CDMI Extension: CIMI

Version 1.1a

Working Draft

Modifications to the CDMI 1.1.0 spec:

Figure 8 - CDMI and OCCI/CIMI in an Integrated Cloud Computing Environment

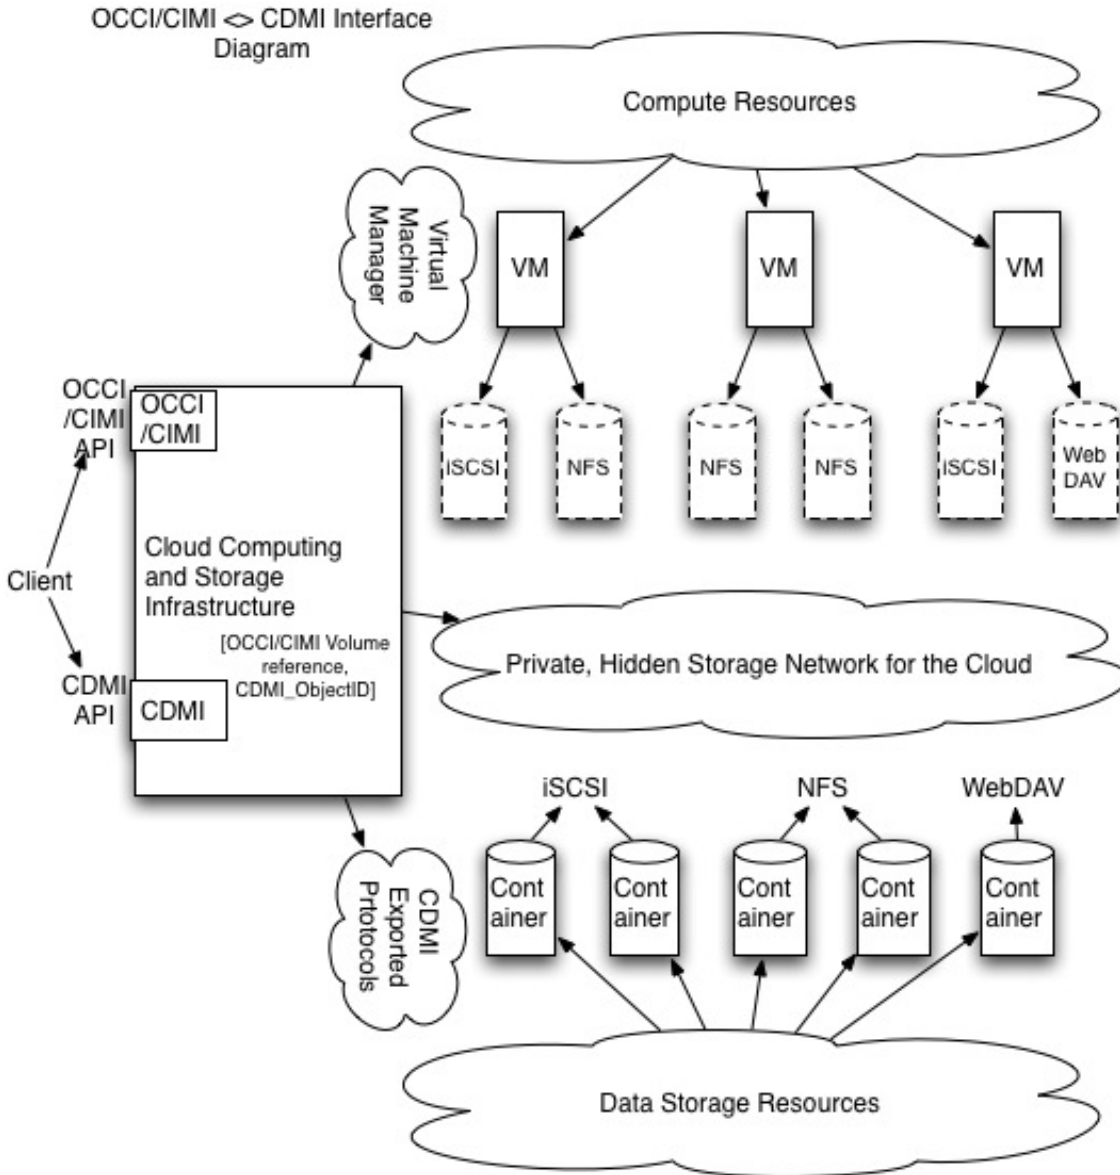
5) Substitute into 13.1 - <entire section>:

For all occurrences of "OCCI" in this section, add references to "CIMI" such that the section reads as follows:

CDMI™ containers are accessible not only via CDMI as a data path, but also via other protocols as well. This access is especially useful for using CDMI as the storage interface for a cloud-computing environment, as [Figure 8](#) shows.

The exported protocols from CDMI containers may be used by the virtual machines in the cloud-computing environment as virtual disks on each guest as shown. The cloud computing infrastructure management is shown as implementing either an Open Cloud Computer Interface (OCCI) or a CIMI along with the CDMI interface. With the internal knowledge of the network and the virtual machine manager's mapping of drives, this infrastructure may associate the CDMI containers to the guests using the appropriate exported protocol.
